Subject: 210 PCH opposition letter

RE: Traffic and Parking Study Comments CUP for 210 Pacific Coast Highway
April 18, 2024

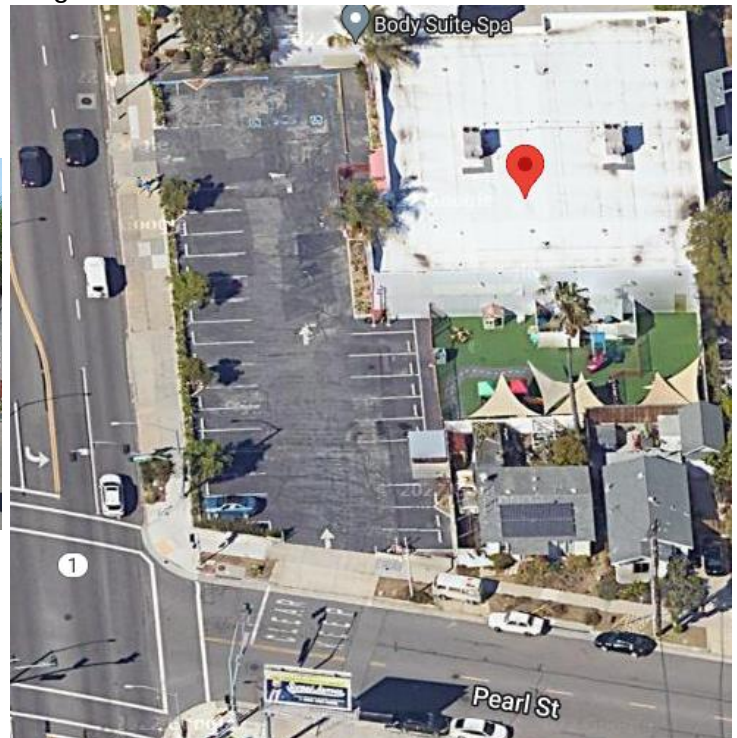
The initial part of 2nd is two-way street where it meets PCH, and then becomes a one-way street, but there isn't room for two-way traffic when cars are parked at the mouth of 2nd street where it joins PCH.

As you can see in this photo looking west on 2nd, where there is a silver car parked on the left preventing the white Audi from entering, when the cars are waiting for the red light to turn green.

They didn't think this through as there will **still be back-ups on PCH** for those **traveling north on PCH turning right onto 2nd** and can't enter due to **parked cars not allowing enough room on 2nd to enter** (See picture on pg 2), except when the light changes, but there will be so much queuing on 2nd, that will be very difficult.

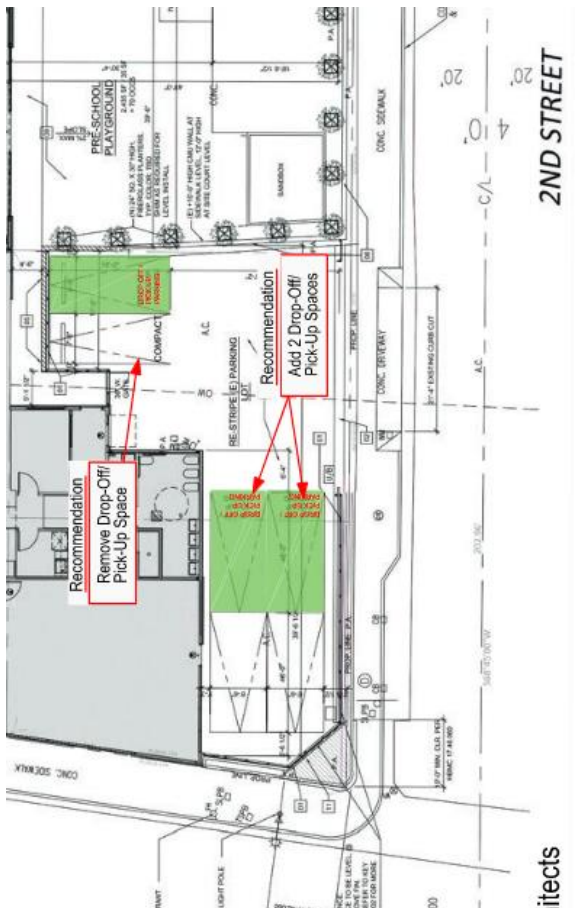
With Children's Journey Day Care on PCH, they followed the law and have the proper amount of **loading/unloading** with a total of **22 parking spots** for a max of **66 kids** (per Winnie.com). This equates to up to **9 spots for employees plus 13 more spots for loading/unloading**, with one entrance from a large two-way street (Pearl), and arrows directing for one exit onto PCH:

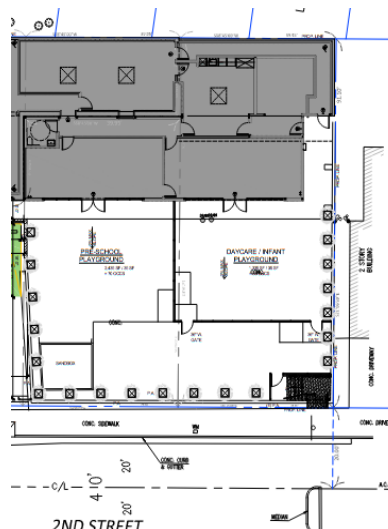
In the first draft of CUP/Parking Plan Analysis & Findings, the applicant is wants to increase the day care to **98 kids** (and with the current plan would allow for 144 kids), but since the first draft, they deleted the end of the 2nd sentence re: 98 kids, and even left it blank on your current copy (without moving up the next sentence):

What control measure will be put in place to prevent more than 77 kids at the daycare. This also needs to be part of the CUP. They only want to get the interior square footage from the back of the building to grow the facility larger, violating the CUP for 77 kids.

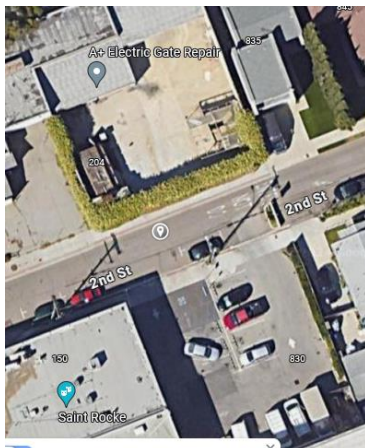
A more appropriate plan would be to have all **5 spots for drop offs on PCH**, along **with 2-spots on 2nd**. The two front tandem spots would be for staff (minus 2 at the entrance to back parking lot to enter garages), along with **retaining the garages for staff for 12 spots.**

Keeping the back garages allows for 12 spots (8 as tandem) for staff that is sorely needed to free up spots in the front of the lot for unloading and loading! This would still give the applicant more interior sq ft than is needed (4,094 sq ft). You’ll note that the plans show that only the front of the building is needed for 80 kids.

The 7 loading spots in the front will still not be enough on at peak times, so the Okell’s lot should also be used for the extra 7 loading spots that will be needed.
